UNITED STATES PATENT AND TRADEMARK OFFICE

APPLICATION NO.	FILING DATE	FIRST NAMED INVENTOR	ATTORNEY DOCKET NO.	CONFIRMATION NO.
10/598,447	09/20/2006	Jamie Oag	OPT-01	5335
23508 7590 11/17/2011 LUNDEEN & LUNDEEN, PLLC 2710 Louisiana HOUSTON, TX 77006			EXAMINER JONAITIS, JUSTIN M	
			ART UNIT 3752	PAPER NUMBER
			NOTIFICATION DATE 11/17/2011	DELIVERY MODE ELECTRONIC

Office Action Summary	Application No. 10/598,447	Applicant(s) OAG, JAMIE	
	Examiner JUSTIN JONAITIS	Art Unit 3752

The figure below is reproduced from the Allen reference in order to show examiner's interpretation.

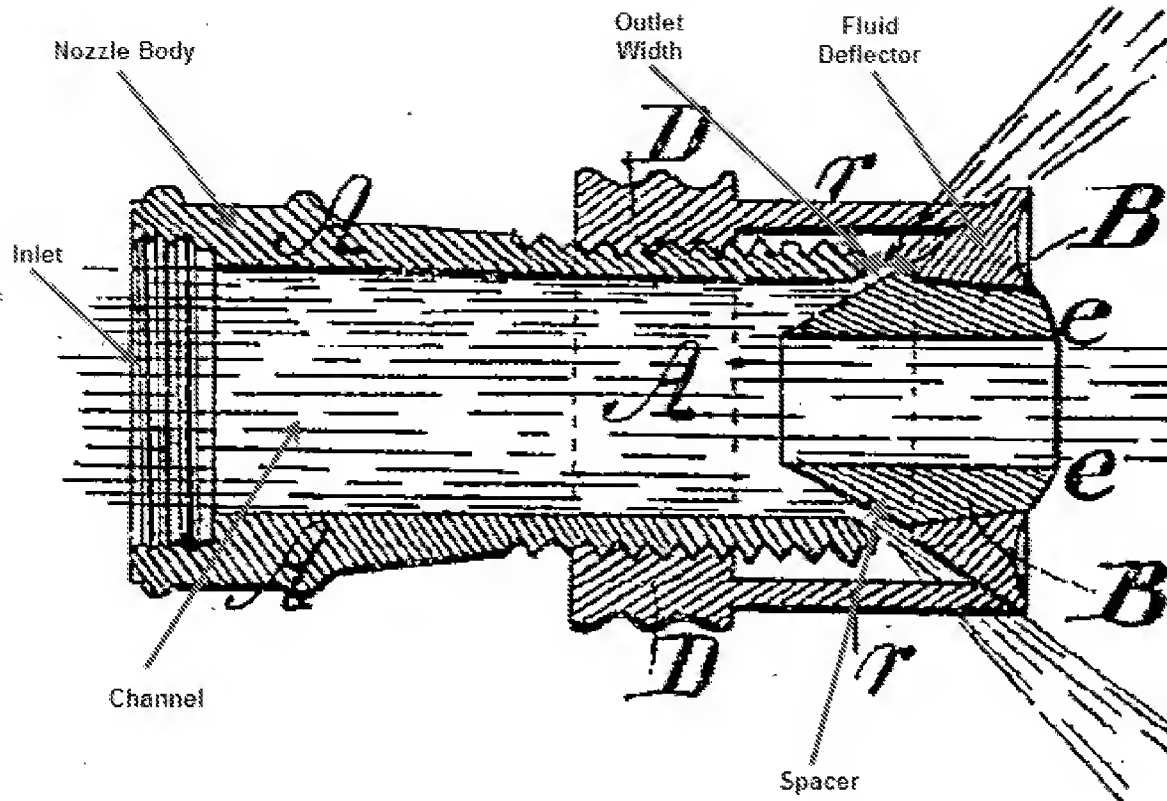
Allen discloses a kit of parts for a nozzle for a hose comprising: a nozzle body (nozzle-piece (A)) having an inlet and an outlet and a channel extending between the inlet and outlet (See Figure above). The apparatus including a fluid deflector and a coupling means (collar (D)) coupling the fluid deflector to the body and arranged near the downstream end of the channel adjacent the body outlet. The fluid deflector and the body together define a width of an opening from the channel at the downstream end. The channel opening width being variable by adjusting a position of the fluid deflector relative to the body.

The body inlet and the body outlet and the fluid deflector are arranged on a longitudinal axis of the body such that the fluid flows from the body inlet along the channel to the body outlet and impinges on the fluid deflector with minimal energy loss prior to impingement on the fluid

deflector. The nozzle comprising a self-cleaning mechanism for adjusting the channel opening width (threaded interaction of the collar and the body is a mechanical mechanism). The fluid deflector determining the direction of flow of fluid as it leaves the nozzle, wherein the fluid leaving the nozzle forms a wall of water.

The deflector being threadably coupled to the body, such that rotation of the deflector relative to the body selectively advances or retracts the deflector relative to the body, thereby facilitating adjustment of the channel opening width.

The figure below is reproduced from the Allen reference in order to show examiner's interpretation.

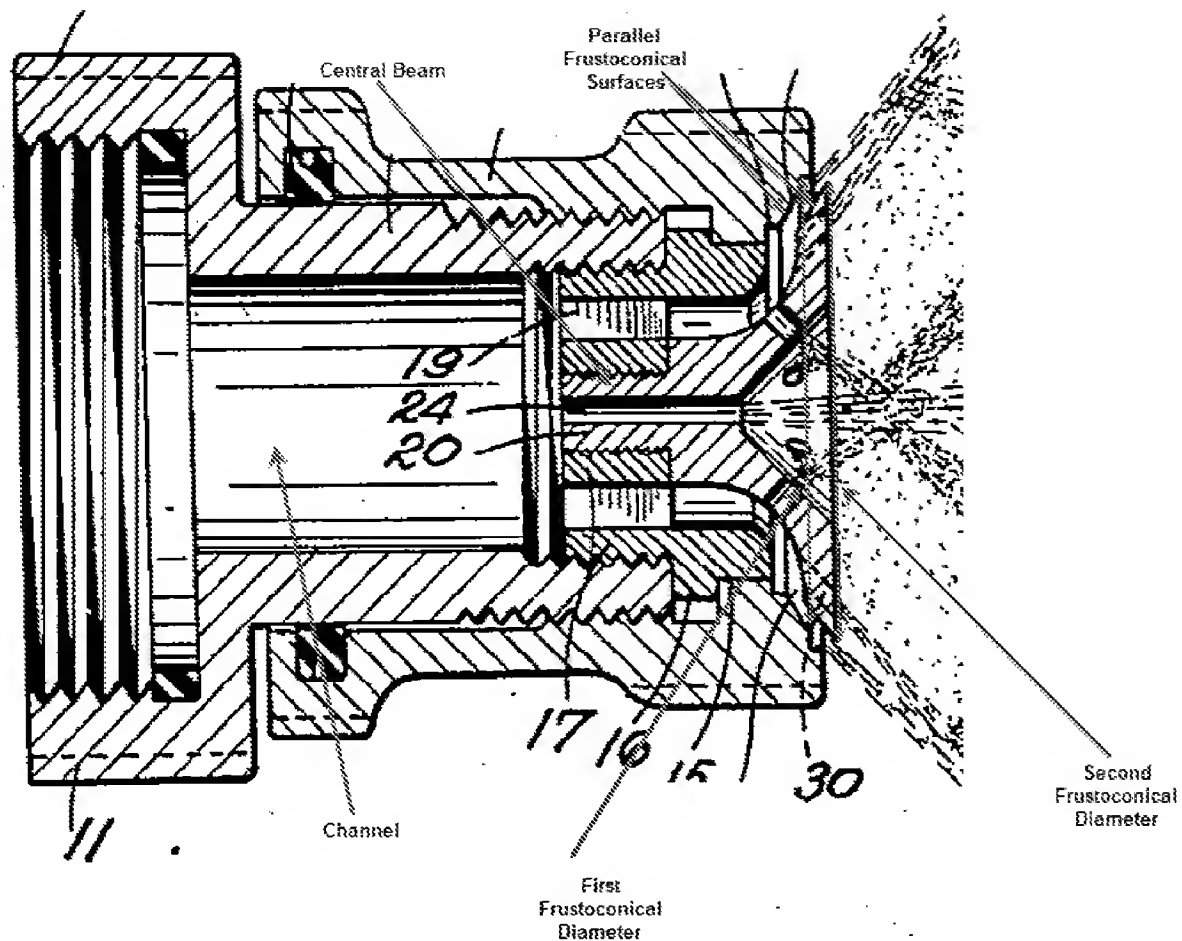
Glessner discloses a nozzle comprising a body (body (10) and sleeve (12)), an annular channel extending through the body from an inlet located at an upstream end to an annular opening/outlet defined by opposing substantially parallel first and second frustoconical surfaces on a downstream end. The first frustoconical surface being formed on the nozzle body, and the second frustoconical surface formed on the fluid deflector. The fluid deflector having an outside diameter that is larger than the outside diameter of the first frustoconical surface. (see Figure above) The angle of the second frustoconical surface with respect to a main axis of the body determines the shape of the water wall formed.

The apparatus including a central beam (see Figure above) disposed in the channel to secure the fluid deflector by being attachable to the body of the nozzle in a position to set a width of the annular opening. Wherein the position of the fluid deflector relative to the body is adjustable via a self-cleaning mechanism (threaded connection between baffle head (20) and thimble (17), is a mechanical mechanism that can adjust the deflector) to vary the width of the annular opening. The width of the annular opening determining the density of the water wall.

The fluid deflector including a deflecting surface positioned relative to the end of the channel to define the width of the first channel opening at the downstream end of the channel. The fluid deflector defining part of the first channel (See Figure, curved portion extends into the channel and therefore defines a portion of the deflector). The deflecting surface disposed at an angle of approximately 105 degrees relative to the main axis of the body such that the deflecting surface is angled away from the direction of fluid flow.

The central beam of the apparatus including a central channel (port (24)) extending through the central beam and through the deflector and the body. The main channel of the nozzle being provided with a space suitable for accommodating a spacer (thimble (17)) suitable for accommodating a spacer to alter the position of the fluid deflector relative to the downstream end of the channel thereby varying the width of the channel opening (threaded portion of thimble portion can be rotated in and out of body (11) to adjust the position of the deflector relative to the end of the channel).

The deflector being threadably coupled to the body such that rotation of the deflector relative to the body advances or retracts deflector relative to the body thereby facilitating adjustment of the channel opening width.
